ADDENDUM NO. 1

CITY OF PLATTSBURGH DOWNTOWN REVITALIZATION INITIATIVE ARTS PARK

SA PROJECT # 2018-039.10

November 6, 2020

C100

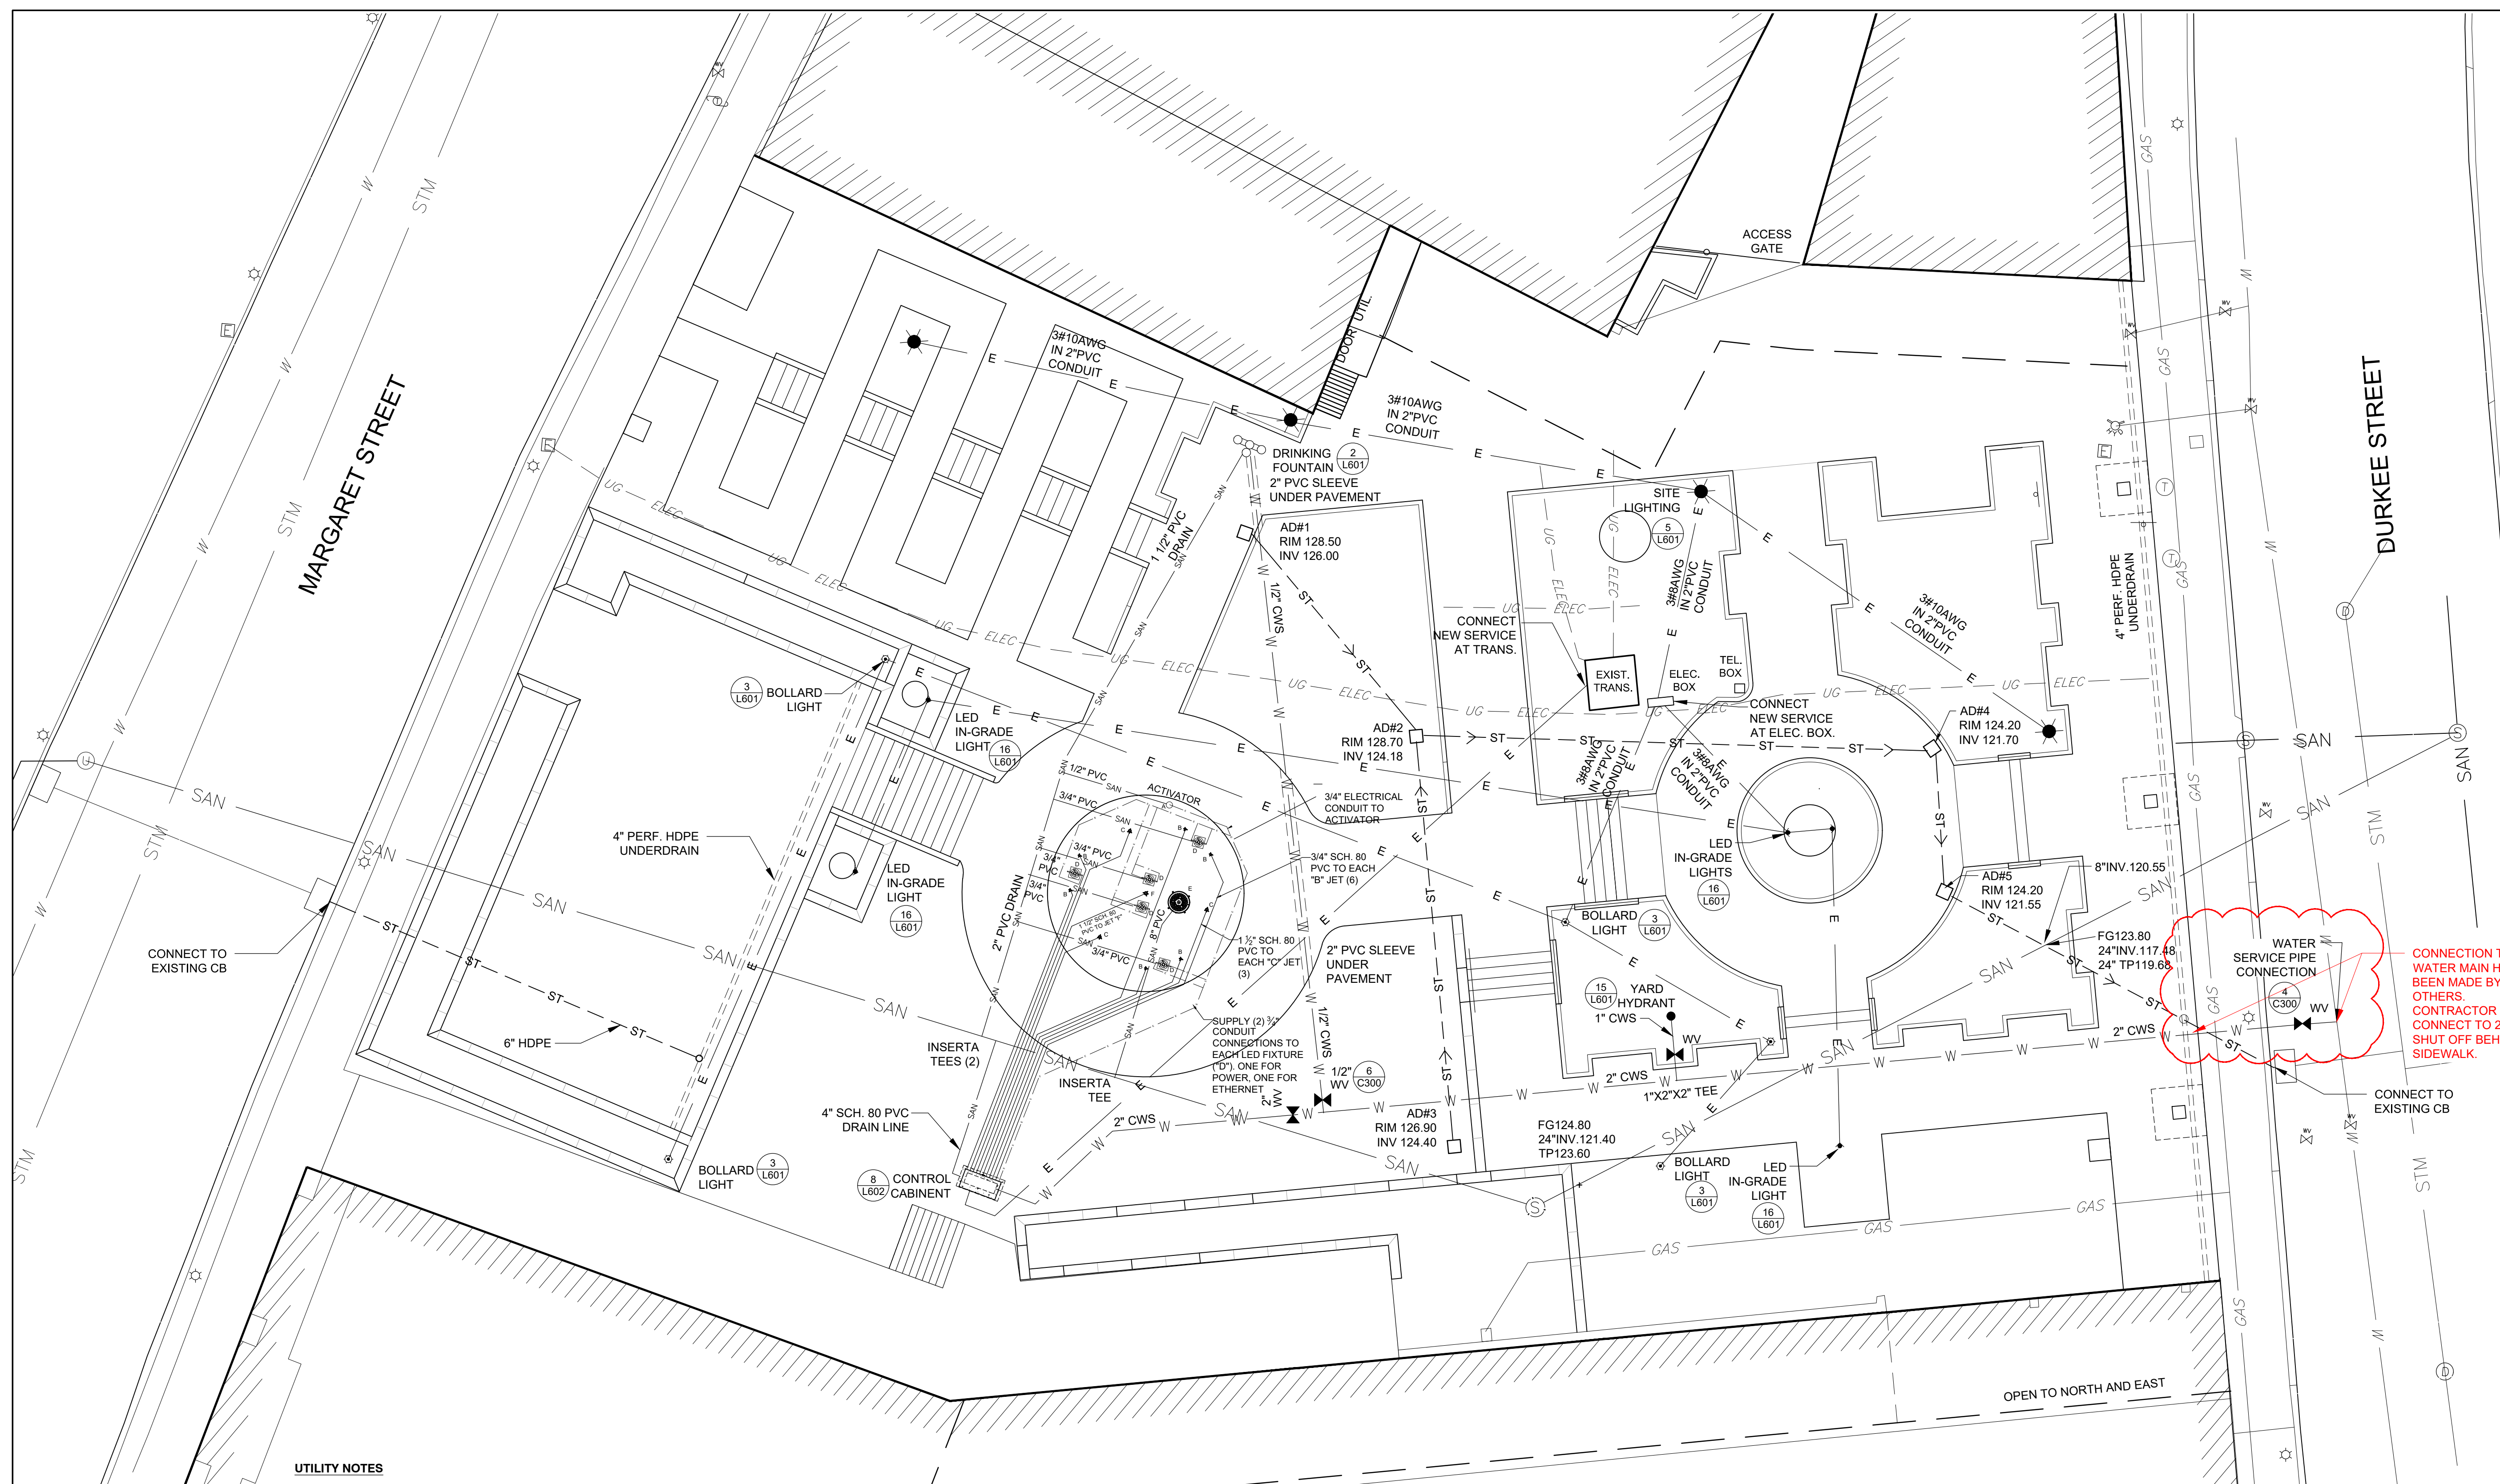
While performing sewer line replacement, Contractor made the water line service connection at Durkee Street, installing 2" water service pipe (17' lf+/- and a 2" gate valve behind the sidewalk. In addition, due to field conditions, the manhole within the park was installed with inverts 4' lower. Please refer to attached updated C100 and L100.

4. Please clarify responsibility for trenching and backfill (by GC, or by each contractor?).
Note: Conflict between C100 notes and Summary/Bid Form specs.

Each contractor is responsible for the trenching and backfill incidental to their work, as per the Summary and the respective Bid Forms. C100 has been updated.
